## **ADDENDUM #2**

### **Rye City School District**

***Issued: 2021-02-05***

**This Addendum No. 2 forms part of the Contract Documents and modifies the original bidding documents dated, January 19, 2021.**

3 Secure Entry and Middle School Office Reflected Ceiling Plan Phase 2  
SCALE: 1/4" = 1'-0"

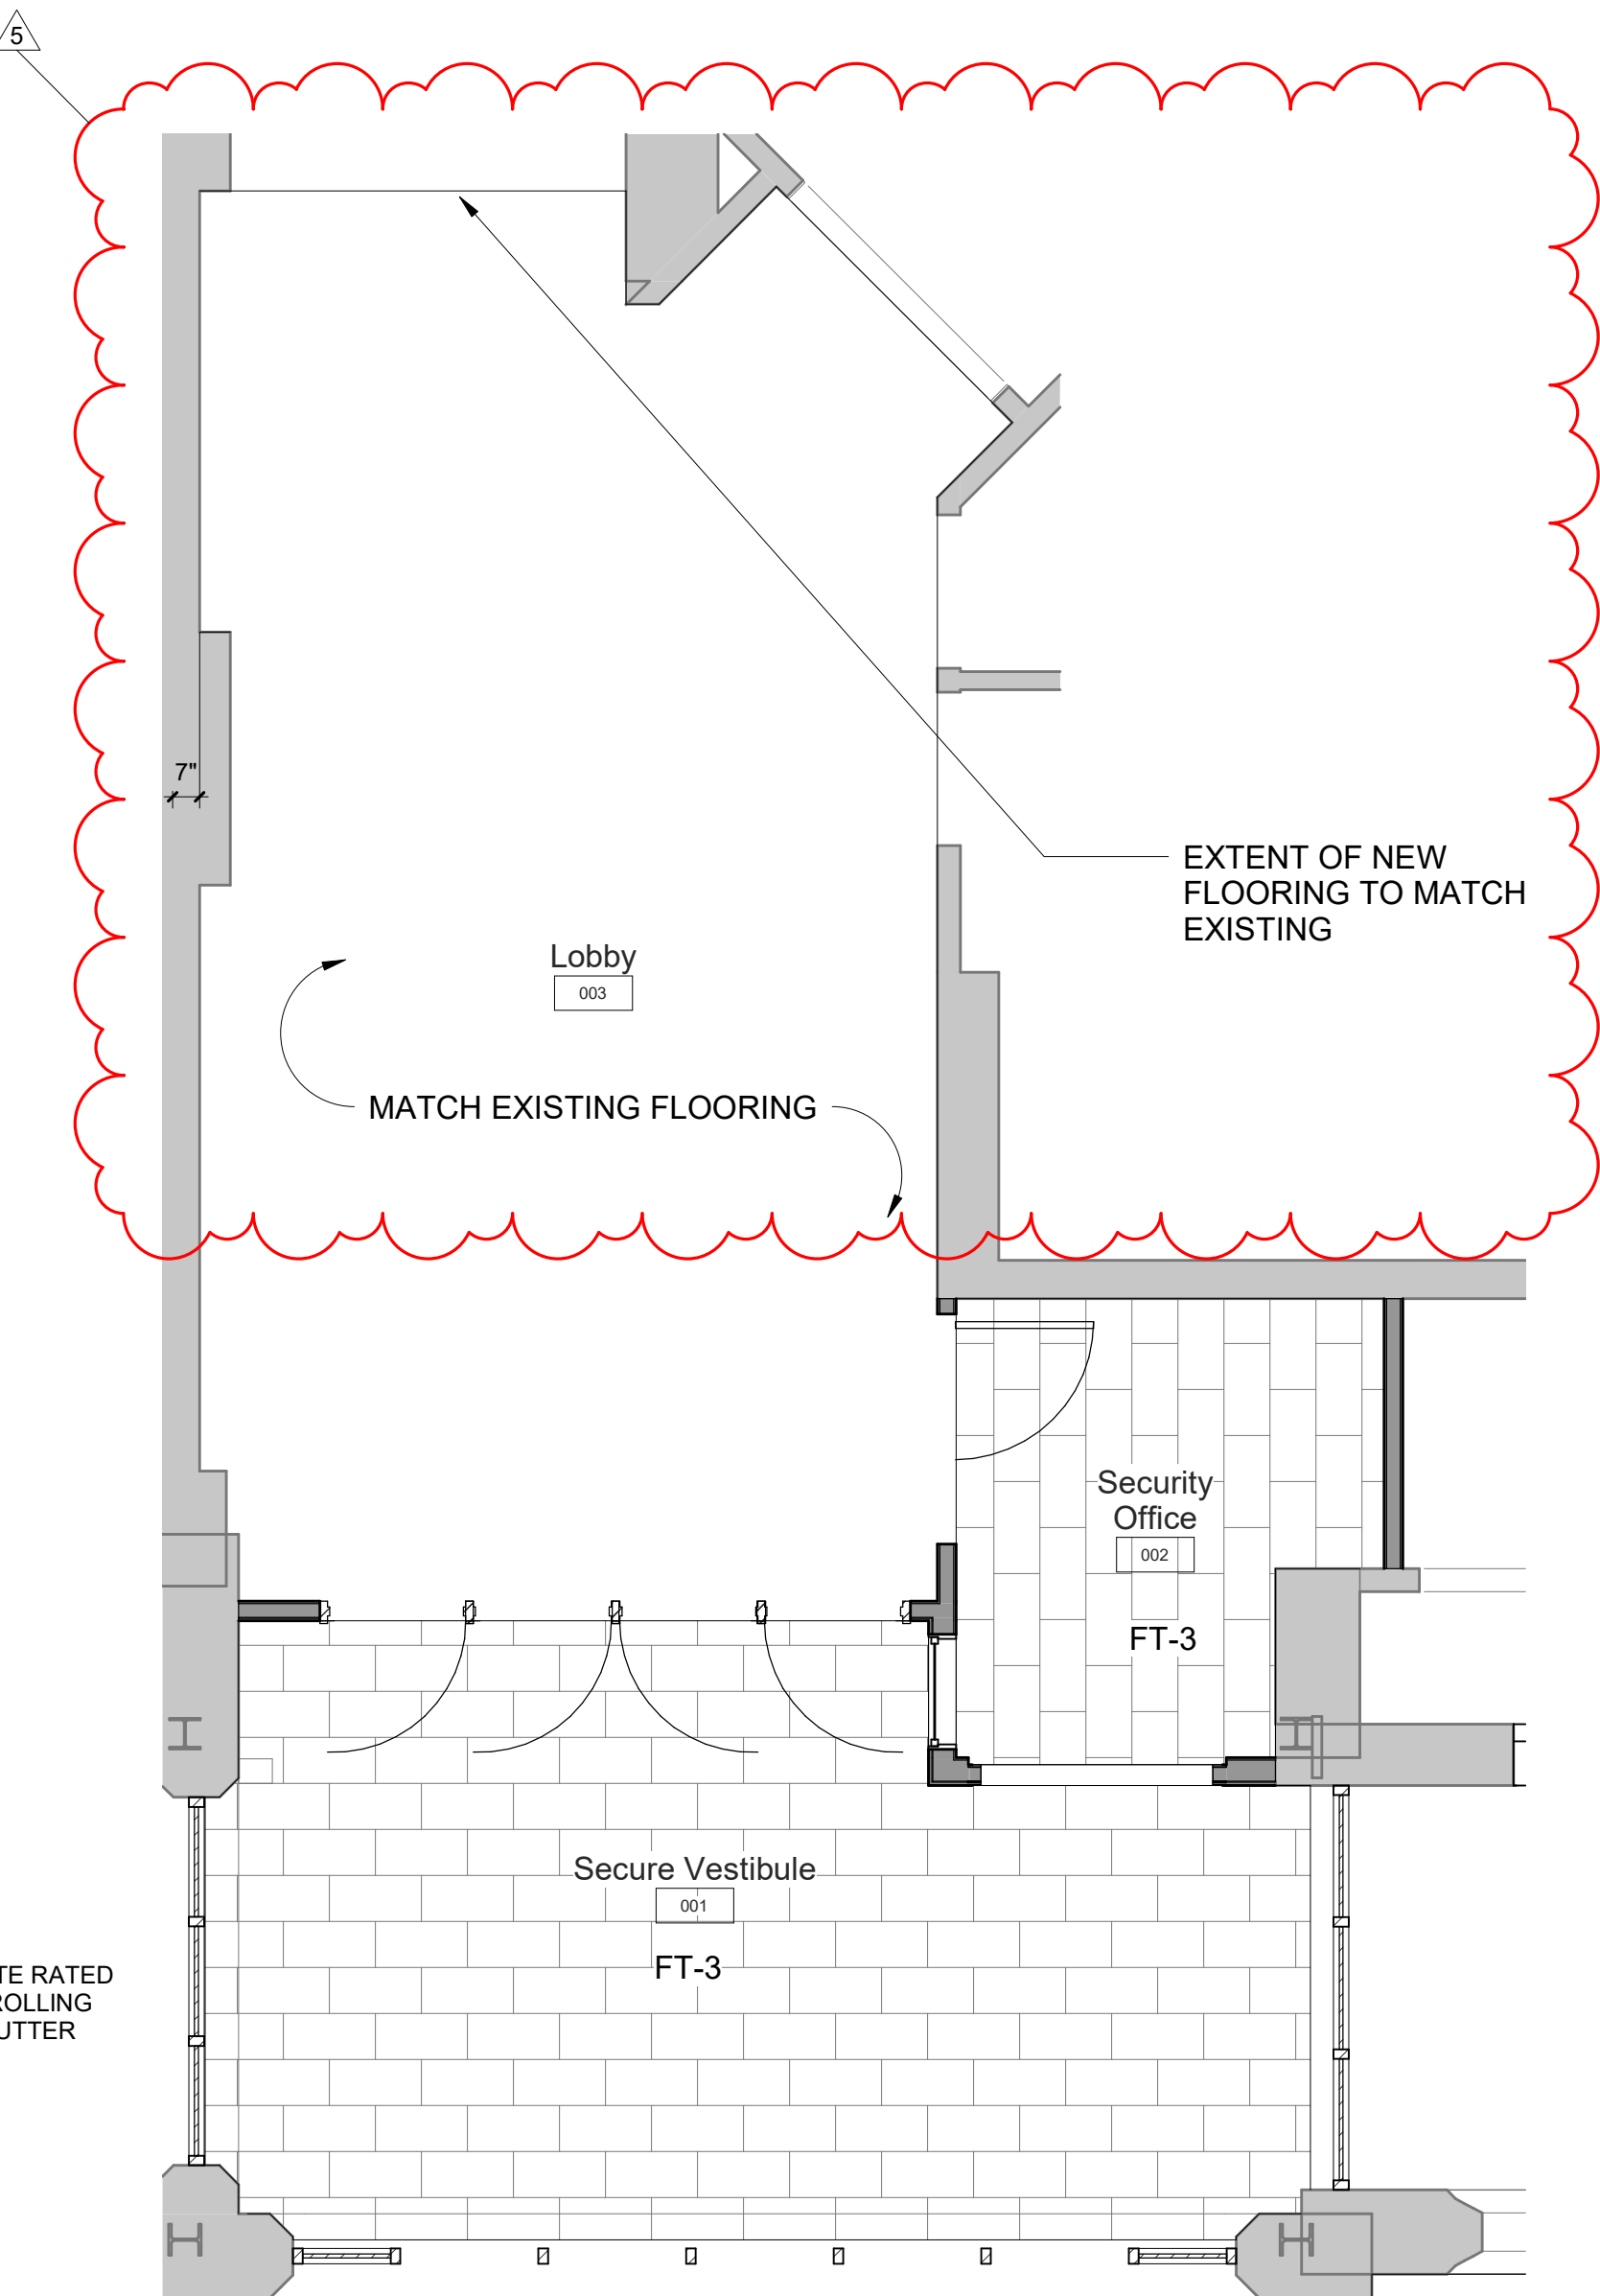
16. A2-402
  - a. Note added for ceiling removal and replacement outside of Classroom 209.
17. A2-501
  - a. Detail #2 – Interior Elevation tag updated to reference appropriate drawing.

SEAL & SIGNATURE	DATE:	11/07/20
	PROJECT No:	92
	DRAWING BY:	BGA
	CHK BY:	BGA
	DWG No:	H2-107

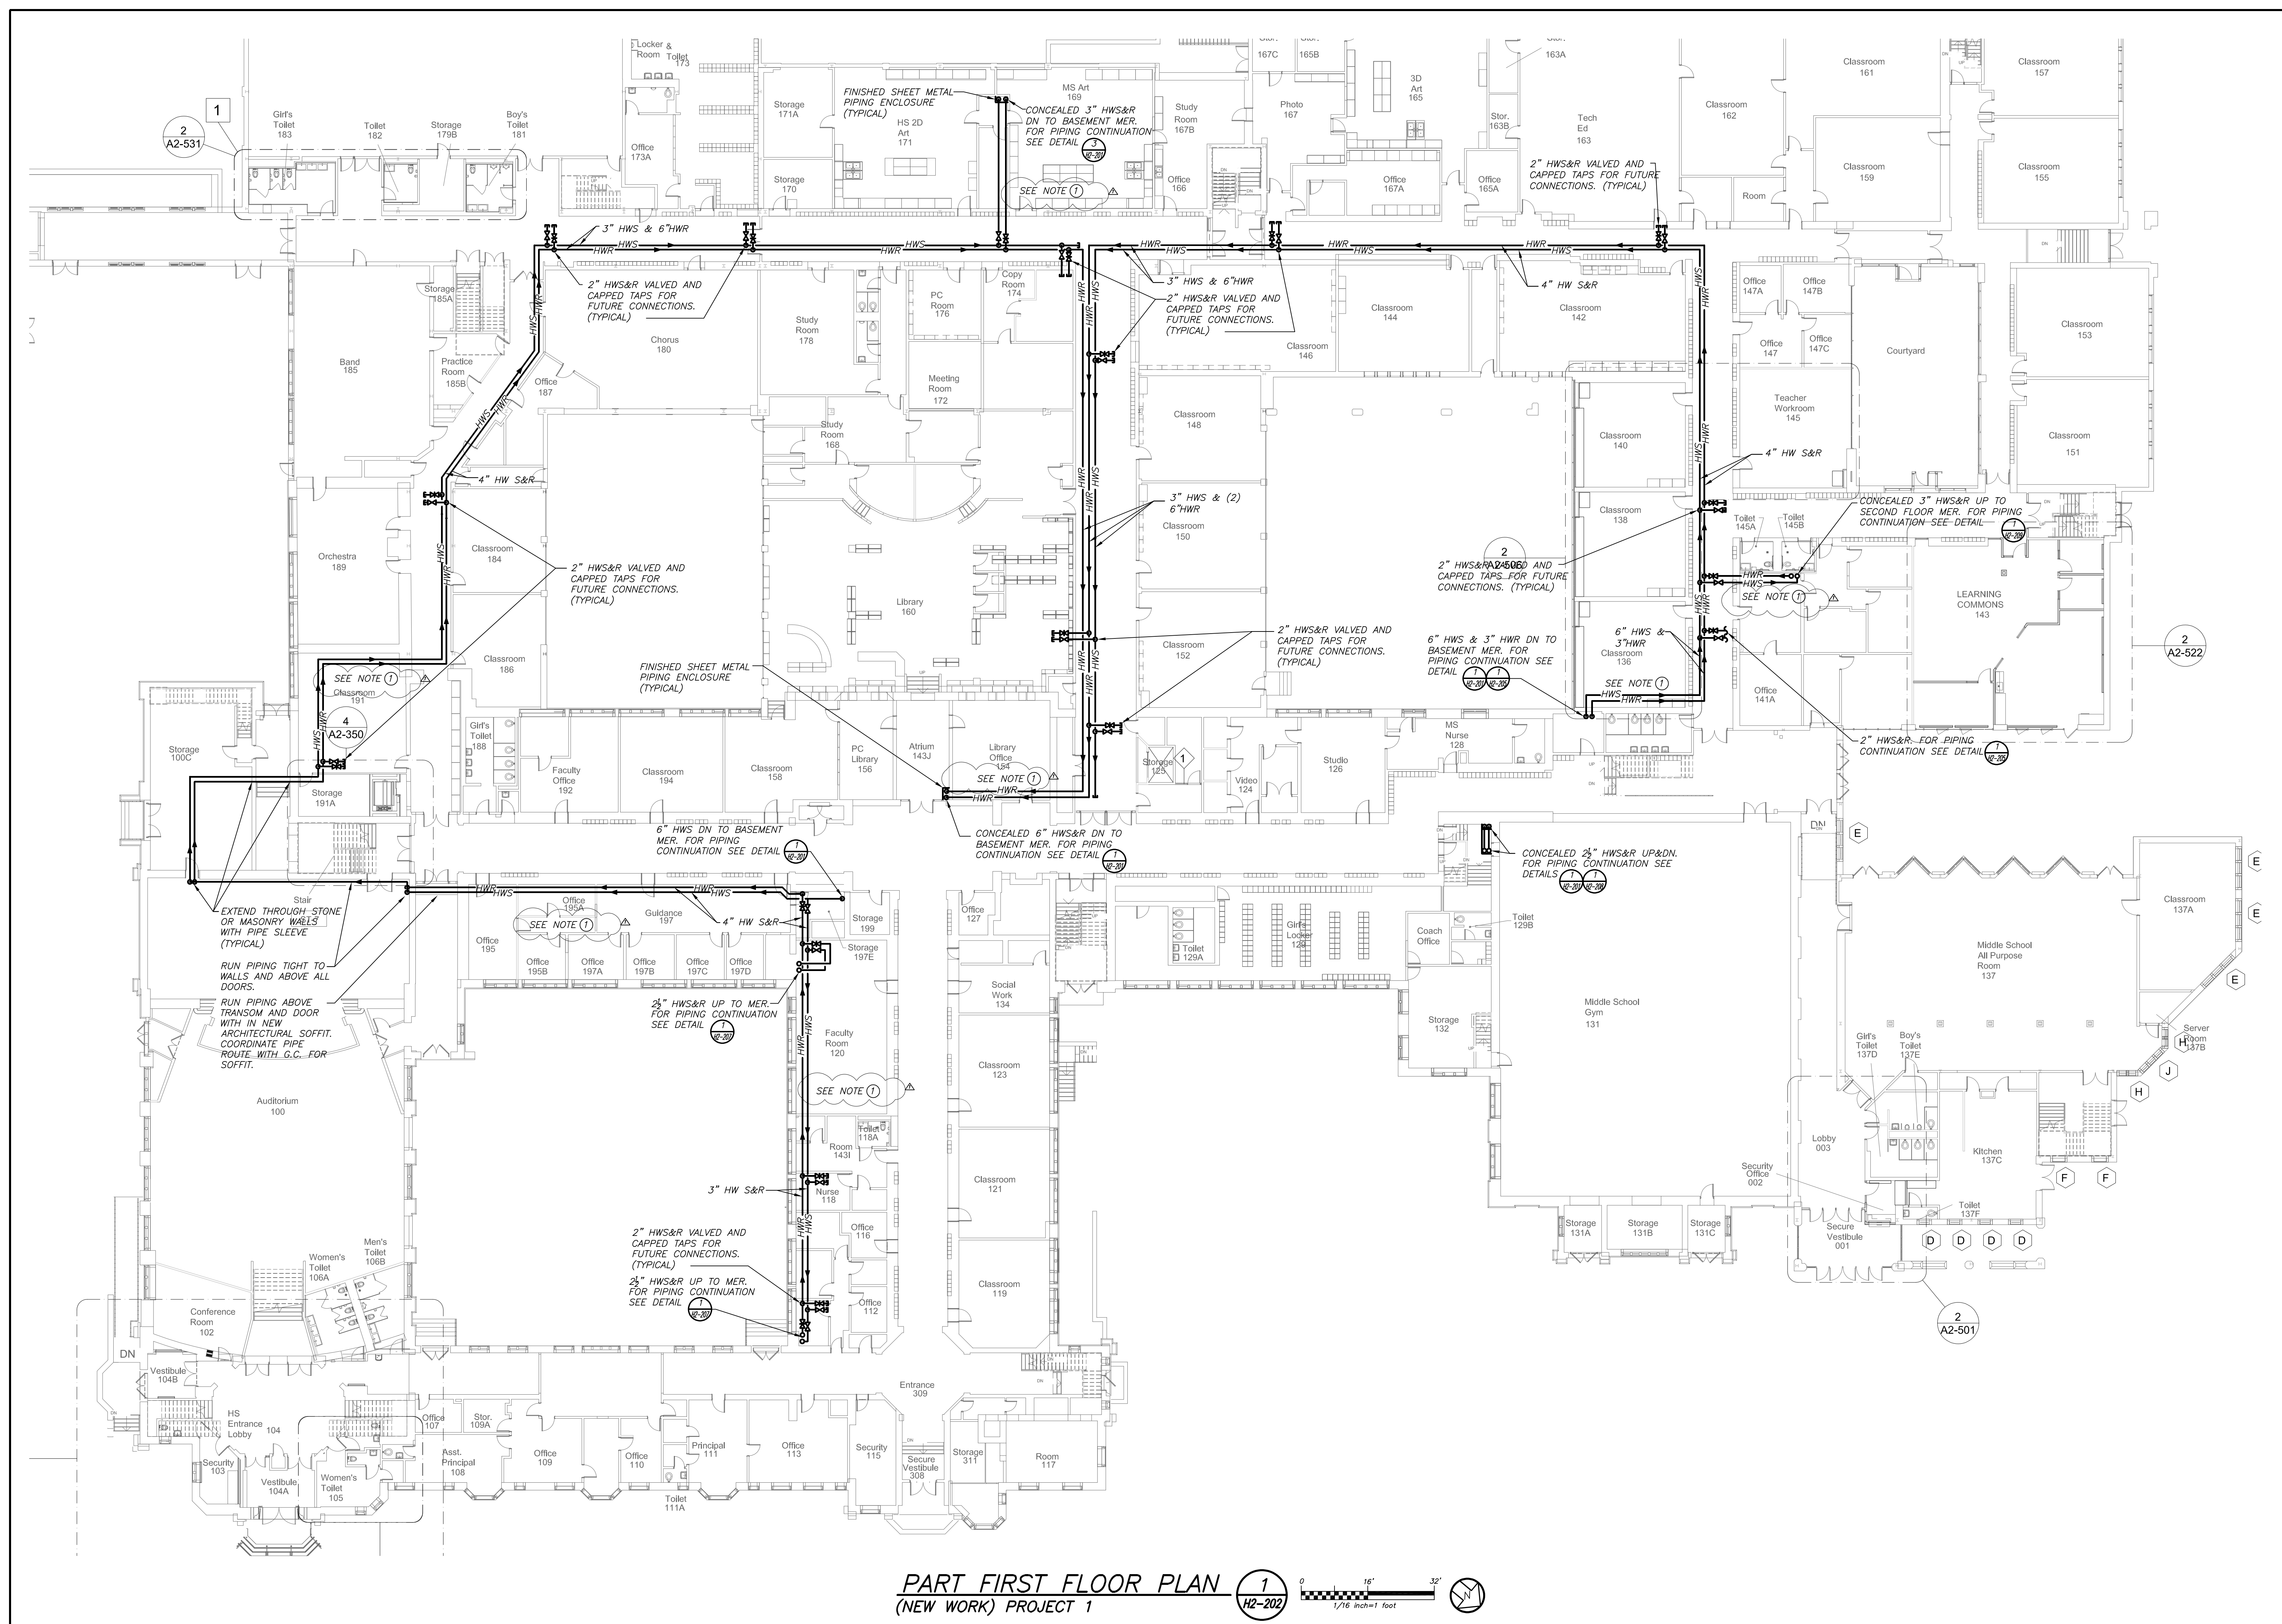
4. Drawing H2 – 107 Part Second Floor Plan
  - a. Move unit ventilator replacement work from Project 1 to Project 4.
5. Drawing H2 – 202 Part First Floor Plan
